UNITED STATES
NUCLEAR REGULATORY COMMISSION
OFFICE OF NUCLEAR REACTOR REGULATION
WASHINGTON, D.C. 20555

NRC BULLETIN NO. 88-01: DEFECTS IN WESTINGHOUSE CIRCUIT BREAKERS

Subject			Westinghouse Circuit Breakers Type DS/DSL: Welds on Breaker's Pole Shaft			Number			NSID-TB-87-11		
System(s)			All Plant Systems			Date			December 1, 1987		
Affected Plants			All Plants with DS/DSL Circuit Breakers			S.O.(s)			309, 386, BOP		
References			See Below			Affects Safety Related Equipment			Yes <input checked="" type="checkbox"/> No <input type="checkbox"/>		
						Sheet			1 Of 17

FIGURE 1

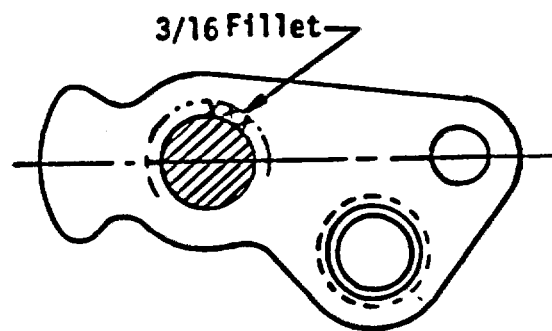
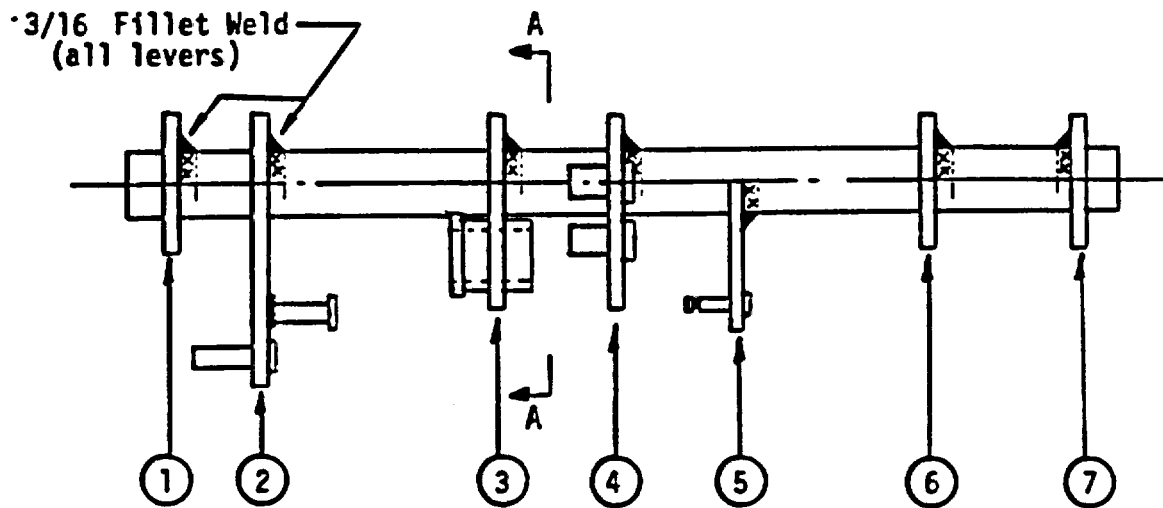
Addressees using Westinghouse DS-206, DSL-206, DS-416, DSL-416, and DS-420 circuit breakers in Class 1E applications, including RTBs, are requested to perform short-term and long-term inspections in accordance with the Westinghouse technical bulletin, except that the following changes should be made to the following sections:

6.0 Add the following:

However, inspection of the 3 main pole shaft welds for all RTBs (both main and bypass) should be completed within 30 days of receipt of this NRC bulletin.

6.1.1, 6.1.2, and 7.1 Add the following:

e) porosity - surface pin holes with cumulative diameters less than 1/16 inch in each inch of weld

6.2.4 Delete this section and the reference to it in Section 6.2.3.

This section lists the criteria to be applied to the welds for the three pole levers on the pole shaft. See Figure 1, items 2, 3, and 6. The remaining welds are discussed in Section 7.0.

This section lists the criteria for acceptance of the 4 welds on the pole shaft, which were not addressed in short-term inspection described in Section 6.0. See Figure 1, items 1, 4, 5 and 7.

With regard to Section 6.2.4, any RTB with a pole shaft that does not meet the criteria in Section 6.1.2 should be deemed inoperable and should not be used in the operating or bypass breaker position in the reactor trip switchgear. Such pole shafts should be removed from service and a replacement pole shaft installed in the breaker before returning it to service. The replacement pole shaft should meet the criteria in Section 6.1.1.

- a) weld size and length - 3/16 inch fillet for 90° continuously around the pole shaft, or 1/8 inch fillet for 120° continuously around the pole shaft
- b) fusion - fused to lever and shaft for the above length
- c) cracks - no cracks are allowed

- a) size and length - at least 3/16 inch fillet for a minimum of 90° continuously around the shaft, or at least 1/8 inch fillet for a minimum of 120° continuously around the shaft.
- b) fusion - good fusion along both legs of weld.
- c) cracks - no cracks are allowed.

FIGURE 3

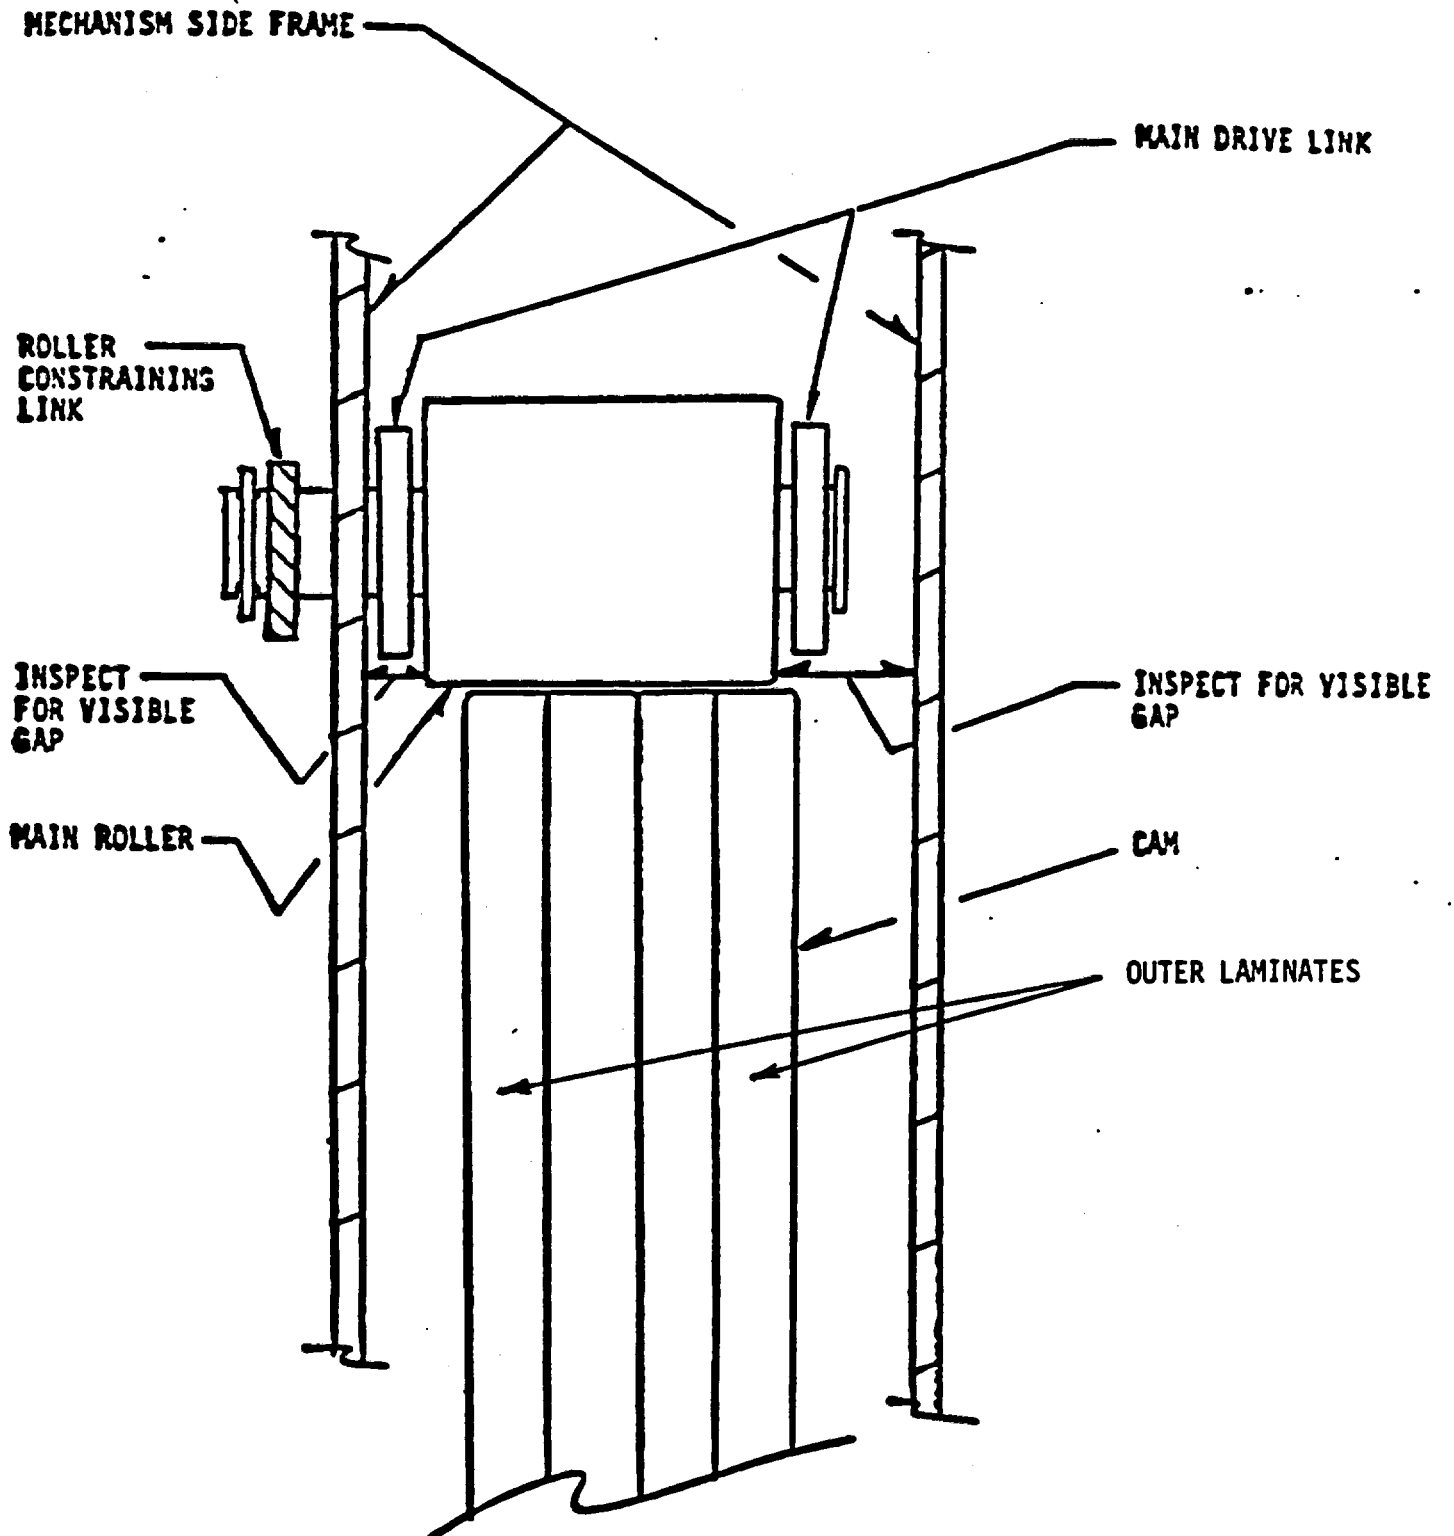
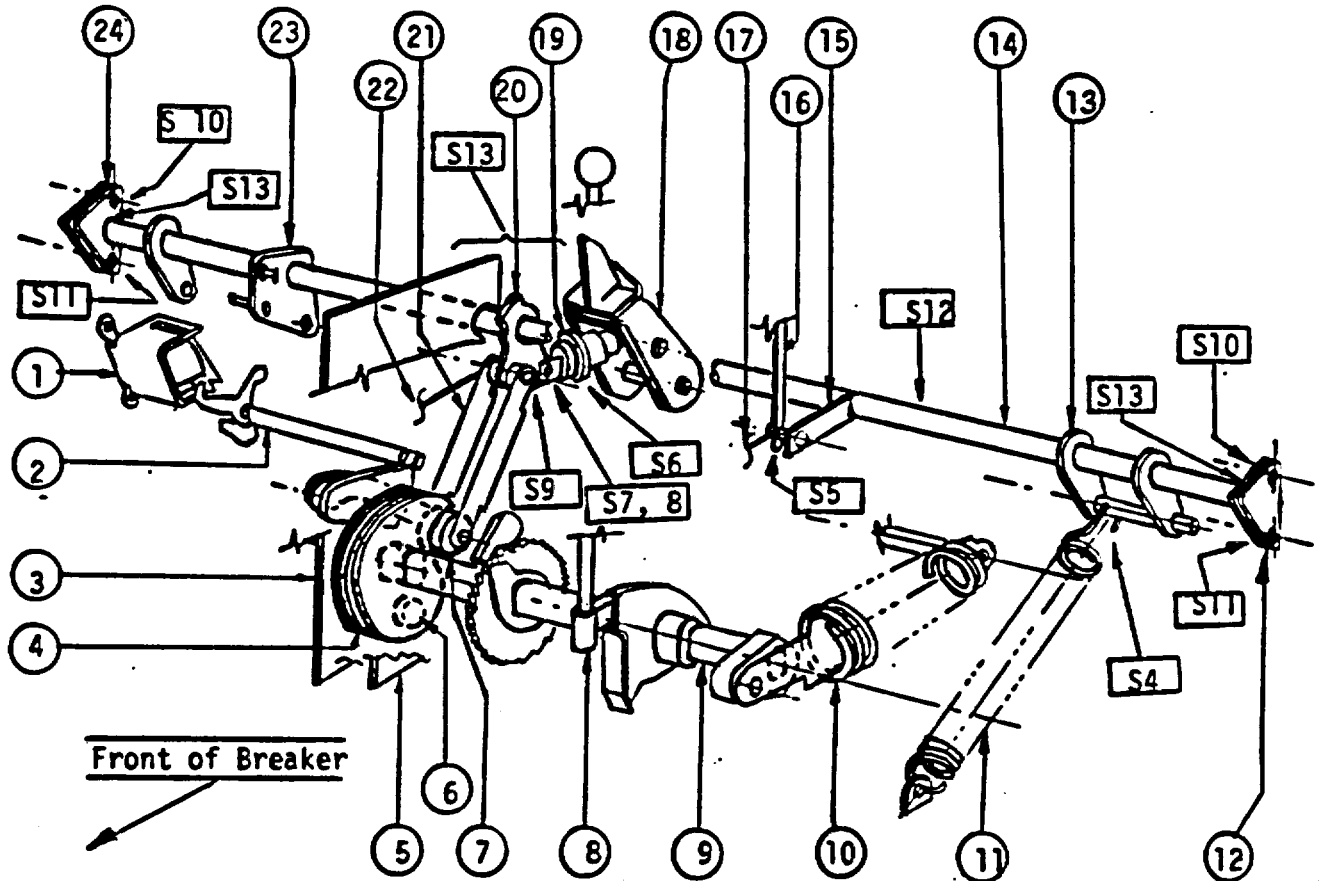
It is recommended that personnel assigned to do this task review Figure 3 before beginning the tasks. It shows the components involved in this procedure.
